SERVICE BULLETIN

APPLICABILITY: 2013-19MY BRZ NUMBER: 09-69-19

SUBJECT: Fuel Pulsation Damper- Service **DATE:** 05/20/19

Procedure Revision

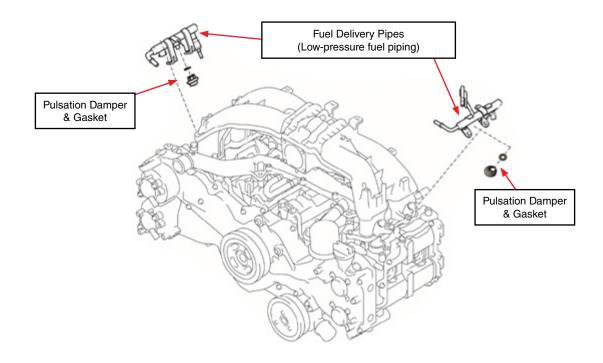
This bulletin provides an additional service procedure for replacing the pulsation dampers located on both low-pressure fuel delivery pipes as shown in the illustration below. Although the BRZ Service Manual does not currently show the dampers and the required replacement seals as separate components, the Electronic Parts Catalog (EPC) does provide exploded view and individual part number ordering information.

Description	Part Number	
PULSATION DAMPER-FUEL	16651AA110	
GASKET- FUEL PIPE	17555AA020

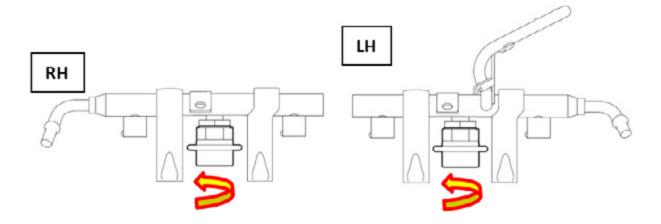
- After removing the affected fuel delivery pipe, **CAREFULLY** remove the pulsation damper.
- **IMPORTANT:** Use caution when securing the fuel delivery pipe to not bend or twist the two mounting brackets while removing the damper. Unscrew the dampers counterclockwise.

• **ALWAYS** install a new gasket before re-installing the pulsation damper. Tighten the damper to 21.6 + / 2 Nm (15.9 + / 1.5 ft. lbs.).
